**SAMISH WAY URBAN VILLAGE MASTER PLAN  
PUBLIC INPUT REPORT  
August 8, 2008**

## Concept View Looking South on Samish Way from Pasco Street (artistic rendering)

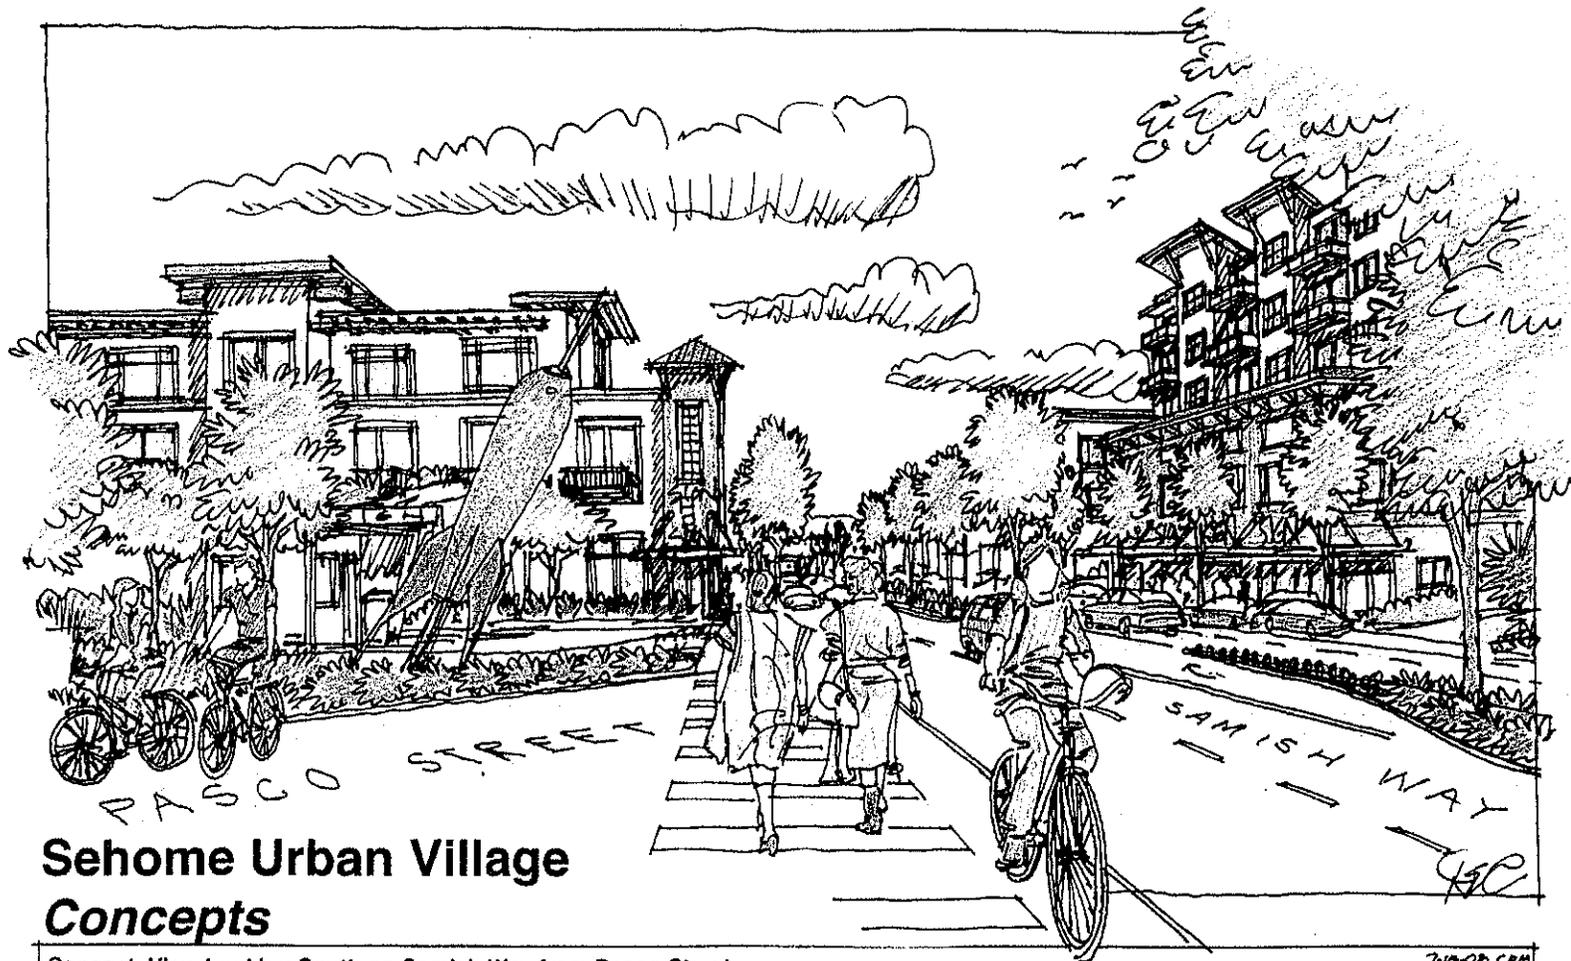
- This is wonderful, but please only have 2 car lanes... more green, less cement.
- Triangle park at Pasco will attract people to spend time in the area.

- This is great! But don't really need 4 car lanes
- This looks great but what about parallel parking on street (Samish) and one lane of traffic each way?

- Lots of green space would add a great feeling of pedestrian friendly
- Would be nice to consider a different architectural style direction than every other new development (design standards)

**Samish Way Urban Village**  
*Preliminary Draft – Core and Transition Zones*

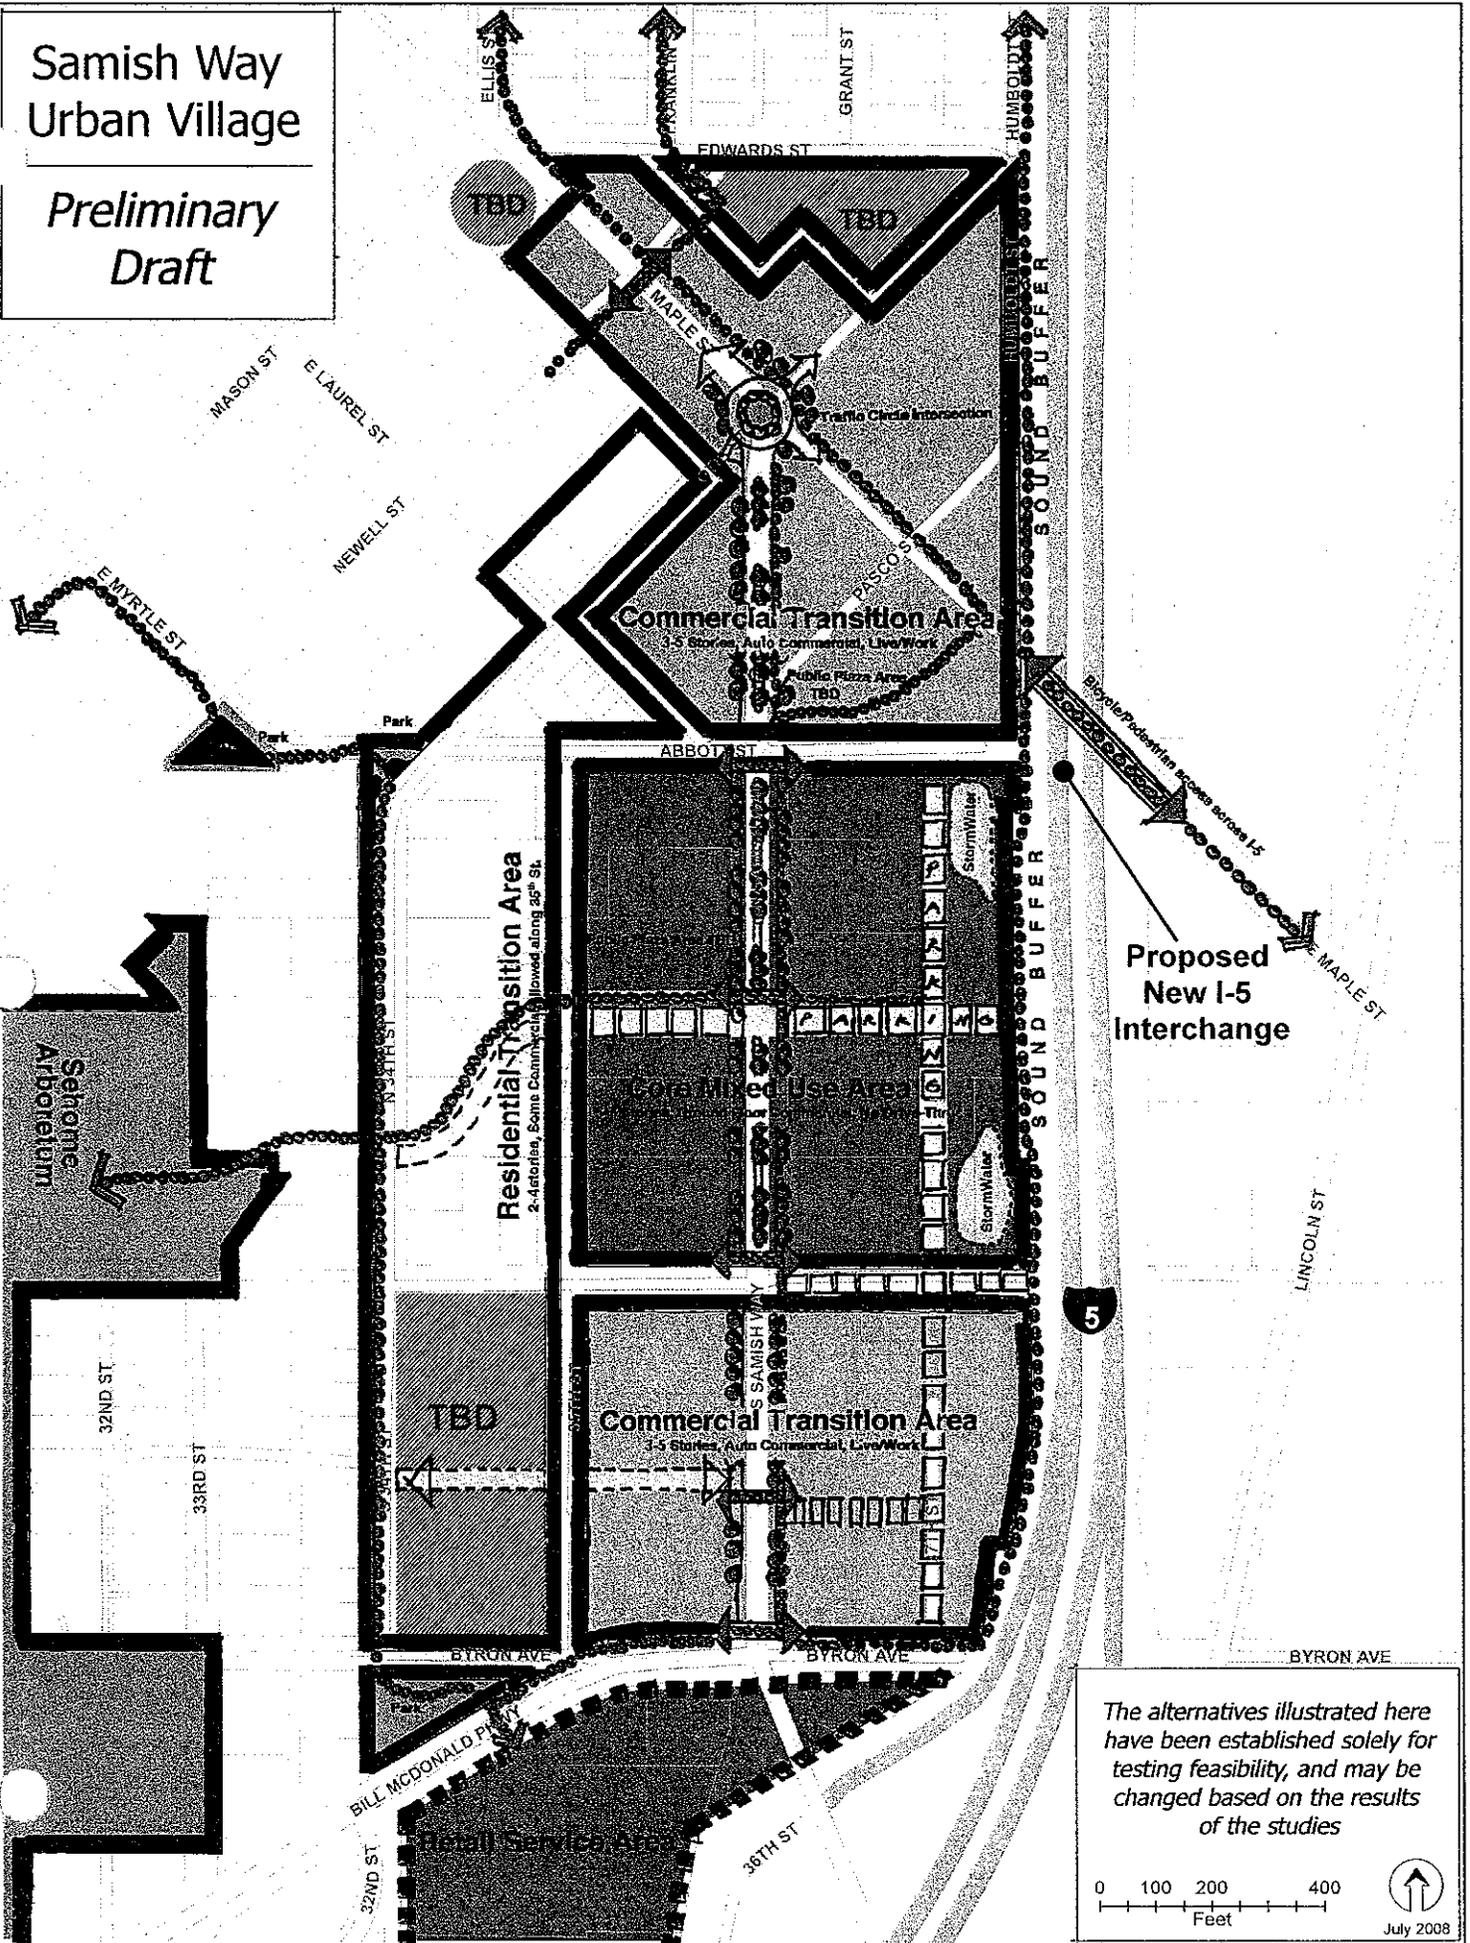
- Haggan's access, 35<sup>th</sup> and Byron must be completely modified. Close Byron to cars when 35<sup>th</sup> is
- Not pleased with drive-thrus coming off Samish, would prefer behind the buildings

- Artist studios and live/work lofts next to I-5 – high rise ok (at southern commercial transition zone)
- Can street material change between districts? Brick, pervious pavement, stone?

- Good to slow traffic at Samish/Maple
- Have DOT responsible for noise mitigation along freeway
- Exit name: Gateway District

Proposed New I-5 Interchange

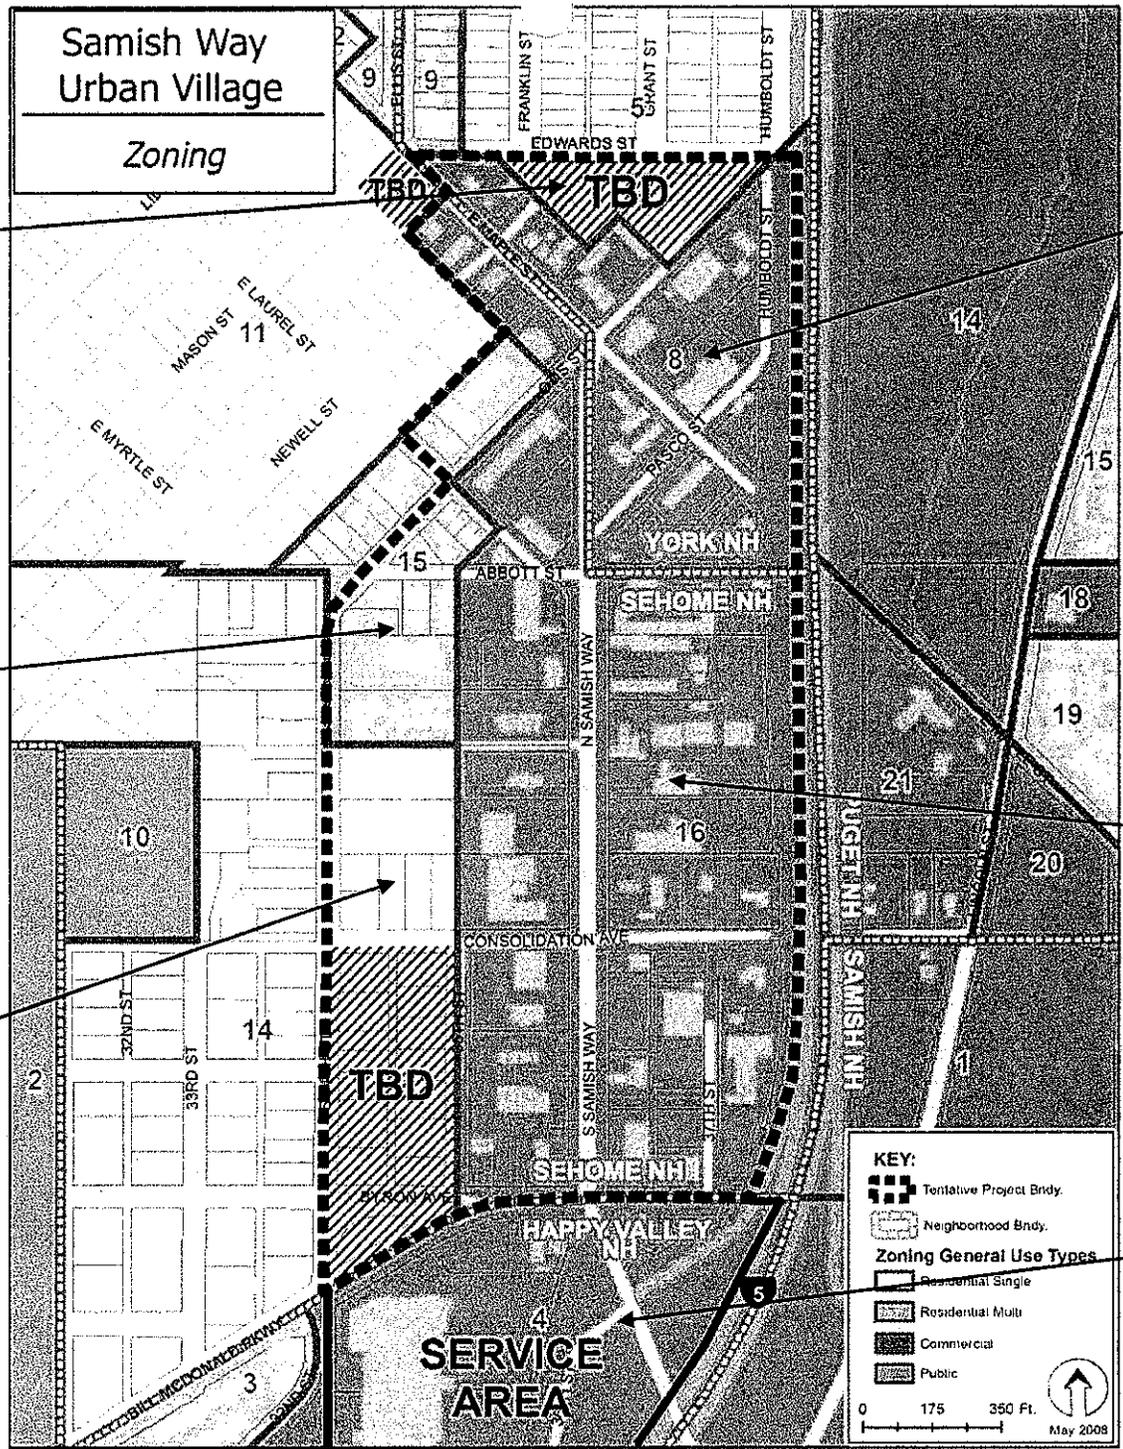
- Make Maple an underpass/overpass, not a highway exchange.
- Get bikes and walkers to the east side of I-5 – but don't add an interchange onto Maple and Laurel.

- No Abbott/Laurel Street freeway exit – that is insane! Better to have overpass from over Samish Way stop up to McDonald Parkway.
- Keep existing exchange but just add new exchange to help traffic.

## Samish Way Street Cross Section – Example B

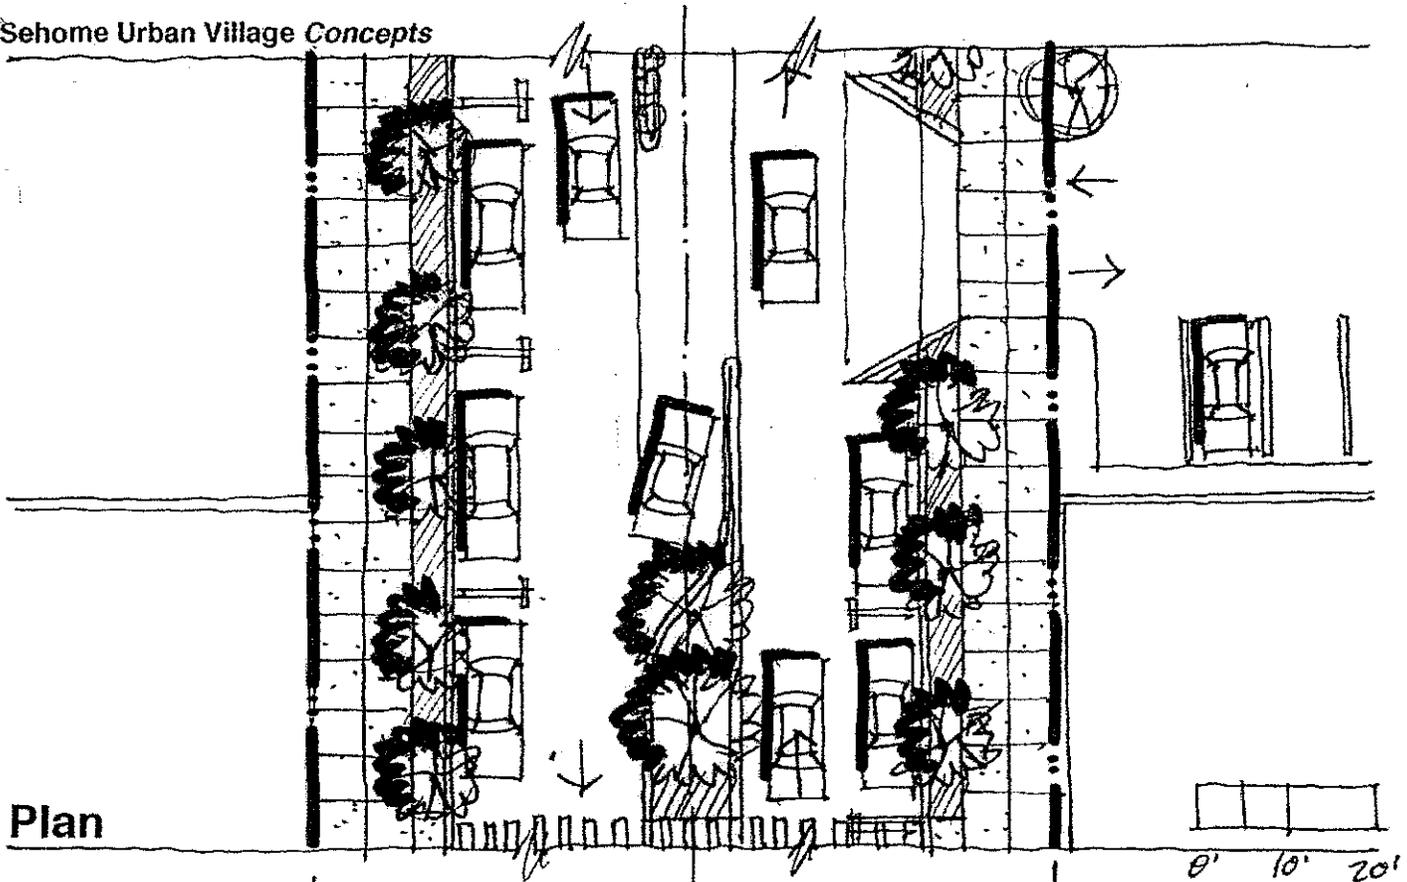
- Good alternative, most friendly for elderly and slow street crossers, also more pleasant sidewalk ambiance
- Plan B is the best
- Better than A, reduce speed to 25mph

- Of A through C options – like B the best, seems to provide best balance; within 100 feet Right of Way we could include bike lanes or café sidewalks

Samish Way Commercial Core; 3 Lane Alt. w/ Periphery Bike Routes

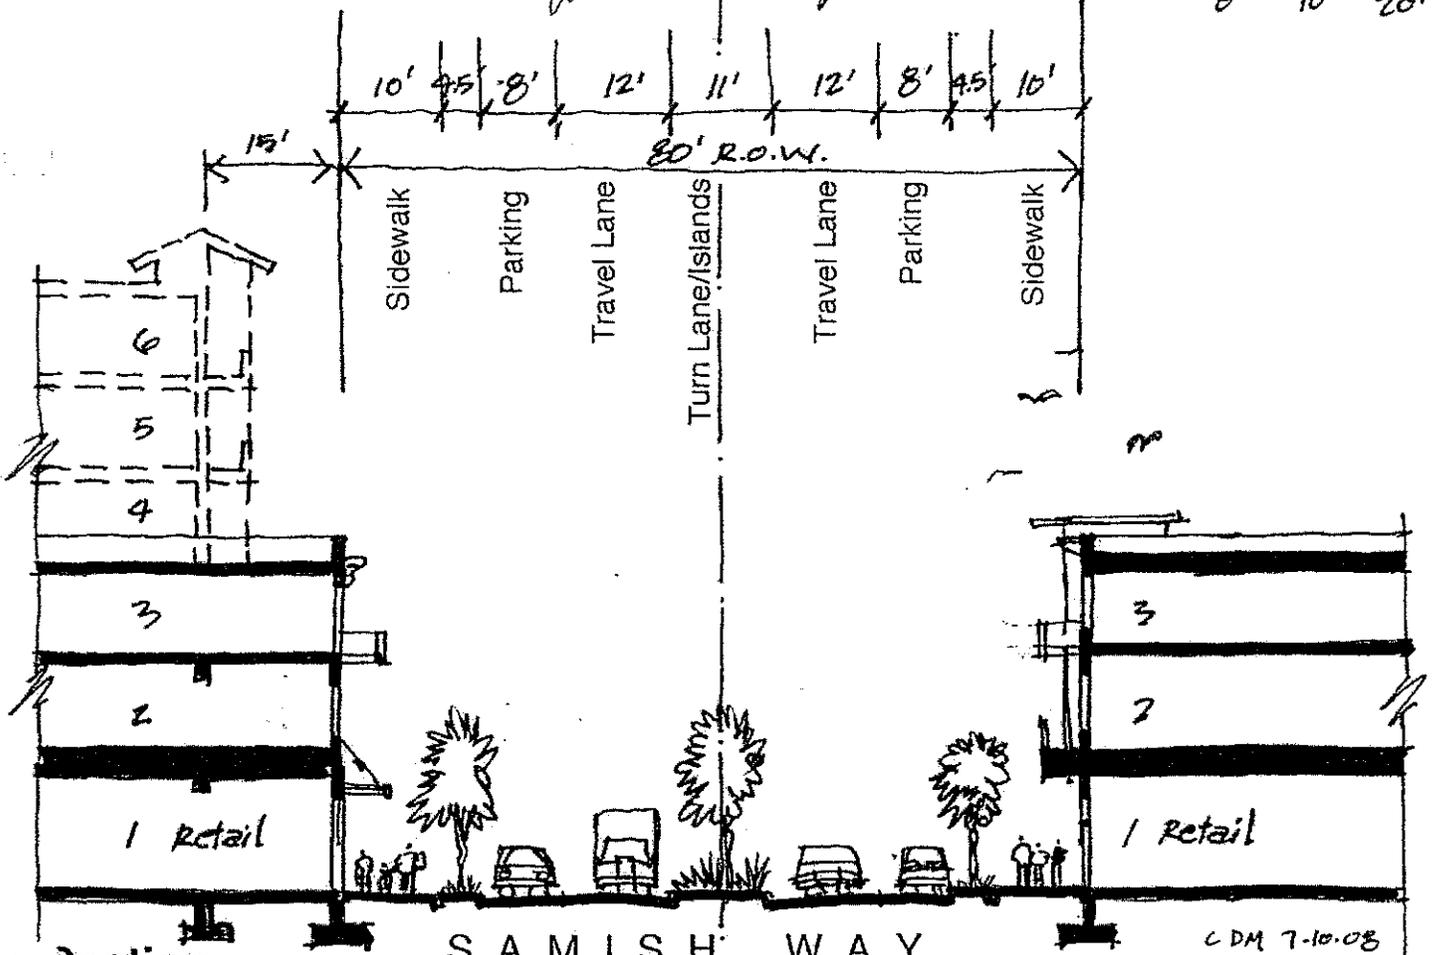
- Too much car orientation
- High priority on bike lanes
- Frontage Street on one side seems bad – creates dead pedestrian zones on half
- This concept feels to me to disconnect the 2 sides, too much like now
